### **ENGINEERING CHANGE ORDER**

REQUEST DATE	2/14/	2020	REQUEST	ED BY H. AMEZQUITA			REQUESTED RELEASE DATE		2/19/2020		ECO # ECO-00		002		
AFFECTED PRODUC	CT LINES	ROLLE	R SHADES, ZEBI	RA SHADES, ROMAN SHADES, SHEER SHADES.											
REASON FOR CHANGE SAFETY MARKINGS FOR PRODUCTS WITH CCO AND TENSION DEVICE															
DESCRIPTION OF CH		CO PRODUCTS WILL INCLUDE A SAFETY WARNING LABELS TO INDICATE THAT THE TENSION DEVICE MUST BE INSTALLED PROPERLY BEFORE ATING THE PRODUCT.													
COST IMPACT \$0.06 USD INCREASE PER PRODUCT (LABELS COST), MEET0123 SCRAP COST: \$4,764.5 USD (65,000 EA @ \$.0733 USD EA)															
DOCUMENT / PART NUMBER	OLD REV	NEW REV	DOCUMENT/ PART DESCRIPTION							CHANGE DESCRIPTION				PART RM, FIT, OR CUNCTION AFFECTED Yes, or No CUNCTION (USE AS IS) (REWORK) (SCRAP) (OBSOLETE) (RETURN TO VENDOR (OTHER)	
MEET0137	N/A	Α	INSTALLATION LABEL CCO PROD ENG-SPA, INDIV PKG BA					NEW LABEL RELEASE					N/A N/A

PART NUMBER: MEET0138

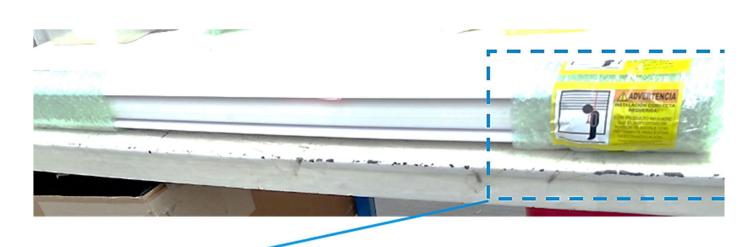
INSTALLATION LABEL CCO PROD ENG-FR, INDIV PKG BAG

FOR CANADA ORDERS USE MEET0138
AS SHOWN ABOVE
